Formula SAE-A Rules Enquiries

Questions and Answers

[Question about template – RE: 07-2020 – 08/03/2020](#)

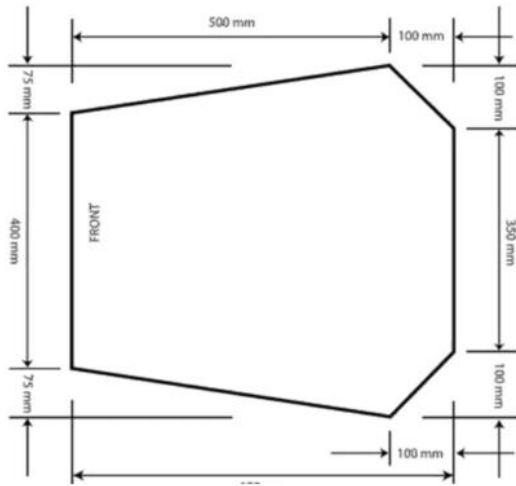
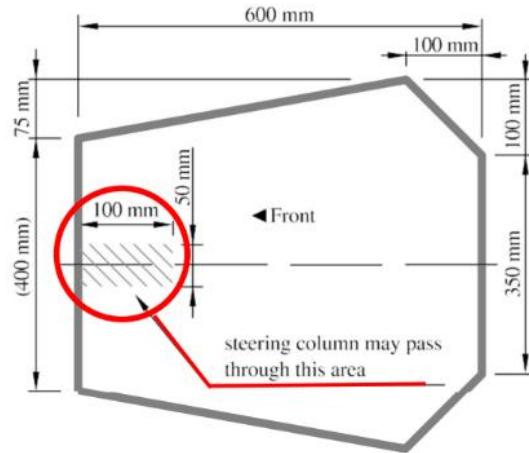
Question: FSAE rules T1.1.1 - cockpit opening template. We are designing our machine for it.

On attached picture left one shows Formula SAE Rules 2020. Right one shows local rule of Formula Student Germany 2020. A cockpit template of FSG has steering column pass through area.

In Australasia competition. Is it same or not?

Aerodynamic Mounting Off Main Roll Hoop Bracing RE: 11-2019 - 07/04/2019

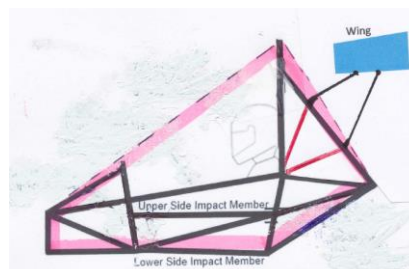
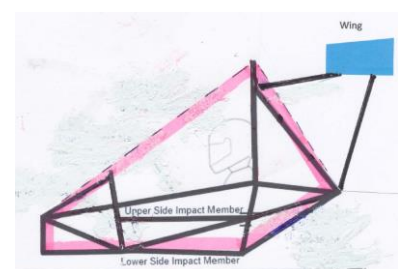
Question (part1): *I was planning to mount a bracket on the backside of the main roll hoop bracing that will then attach to the upper side of the rear wing as a mount (swan neck mount). However, I am confused as to what "additional bracing" must be added to the roll hoops to prevent bending loads in the braces in any rollover attitude?*

Question (part 2): *The rear wing was designed to have a bracket that is attached to the Main roll hoop bracing and top side of the rear wing. However, I am unsure what is classified as "additional bracing" and if there is any particular requirements that need to be met; such as specific areas where there needs to be additional mounting or specific bracing types.*

Answer: To avoid bending loads from anything mounted to the rear braces (such as a wing) from inputting a bending load to them, an additional tube would usually be required at the point where the wing mount attaches to the brace, creating a node which would then attach at the other end to a node on the Primary Structure, thereby creating triangulation and avoiding bending loads.

[Accumulator Fusing Query RE: 09-2019 - 14/03/2019](#)

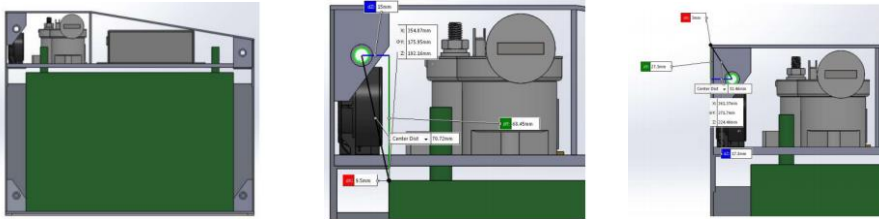
Question: Rule EV.8.1.5 requires that “If multiple parallel battery cells, capacitors, strings of battery cells, strings of capacitors, or conductors are used then each parallel element must have individual overcurrent protection”.

Our proposed cell arrangement is 90s8p. This is made of six segments of 15s8p connected in series. Within each segment, each series step is joined by a bus bar, such that the parallel strings are not separated.

In this arrangement, the parallel cells behave as one cell, and are subject to the overall pack over current protection.
